Well Name: SAN JUAN 28-7 UNIT	Well Location: T27N / R7W / SEC 7 / NWNW / 36.592789 / -107.620697	County or Parish/State: RIO ARRIBA / NM
Well Number: 38	Type of Well: CONVENTIONAL GAS WELL	Allottee or Tribe Name:
Lease Number: NMSF078835A	Unit or CA Name: SAN JUAN 28-7 UNIT--PC	Unit or CA Number: NMNM78413B
US Well Number: 3003907144	Operator: HILCORP ENERGY COMPANY

Type of Submission: Notice of Intent	Type of Action: Plug and Abandonment
Date Sundry Submitted: 04/24/2024	Time Sundry Submitted: 11:09
Date proposed operation will begin: 04/24/2024

**HILCORP ENERGY COMPANY**  
**SAN JUAN 28-7 UNIT 38**  
**P&A NOI**

BLM - FFO - Geologic Report

**SAN JUAN 28-7 UNIT 38 - PROPOSED WELLBORE SCHEMATIC**

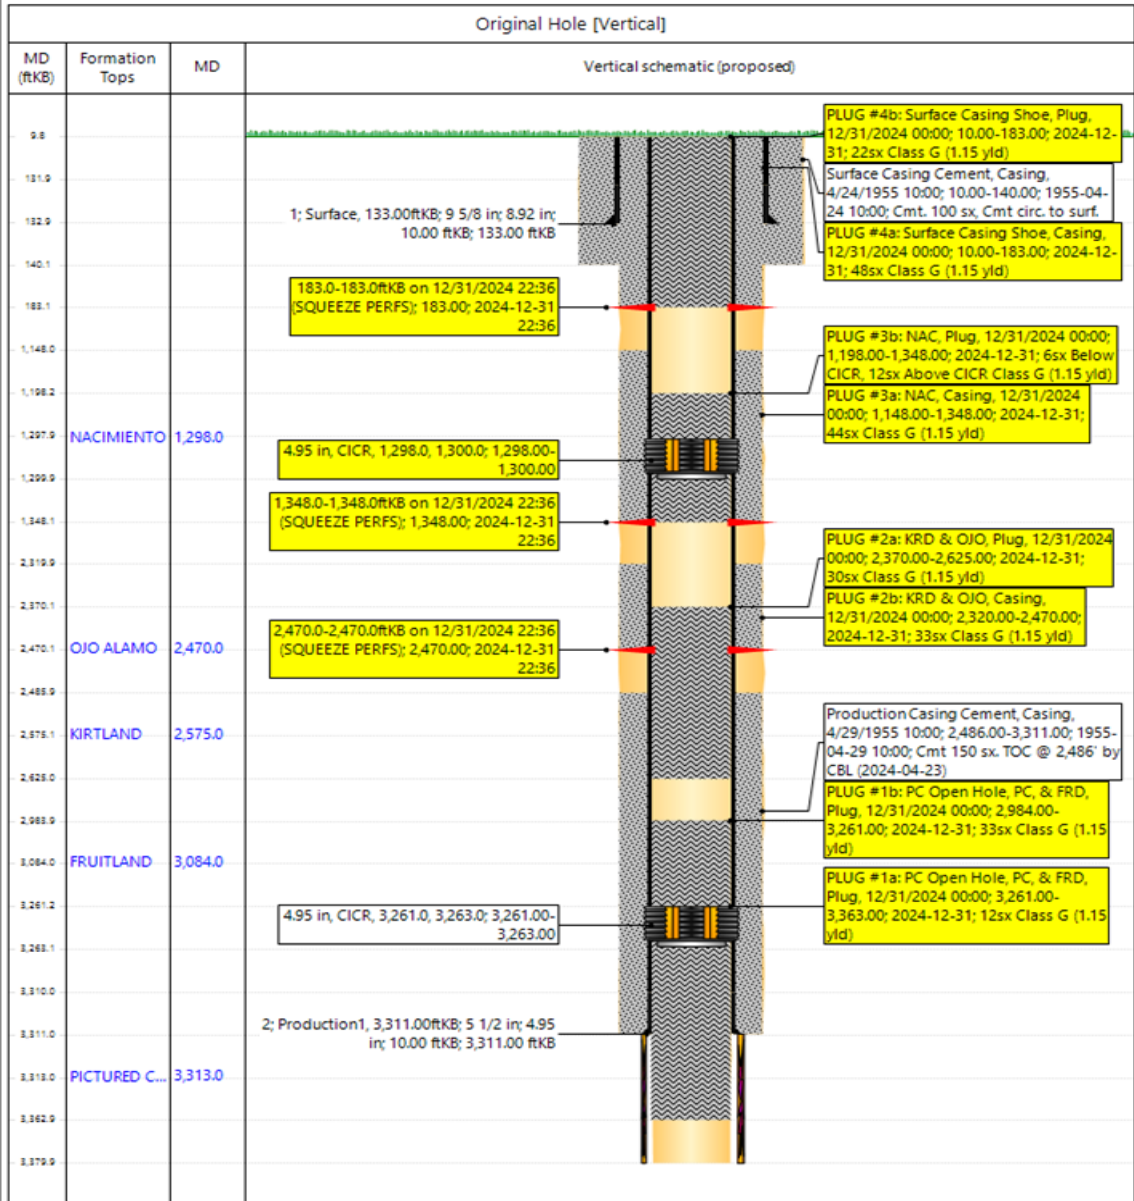
The BLM has approved the NOI to abandoned submission. Note the BLM geologist determined that Ojo Alamo top is higher than operator's pick at 2380.

**The BLM request that the Plug 2 TOC (the plug that covers the Kirtland - Ojo Alamo) be raised to 2280.**

-Move the Plug 3 TOC to 1965' to account for the BLM geologist's pick for the Ojo Alamo top. -- **Change to 2280. 1965 is an error. Updated procedure has the plug being number 2, not 3. Kenneth Rennick BLM PE FFO 04/24/2024**

1. Plugging operations authorized are subject to the attached "General Requirements for Permanent Abandonment of Wells on Federal and Indian Lease."
2. The following modifications to your plugging program are to be made:
  - a. Move the Plug 2 TOC to 2280' to account for the BLM geologist's pick for the Ojo Alamo top.
3. Farmington Office is to be notified at least 24 hours before the plugging operations commence at (505) 564-7750.
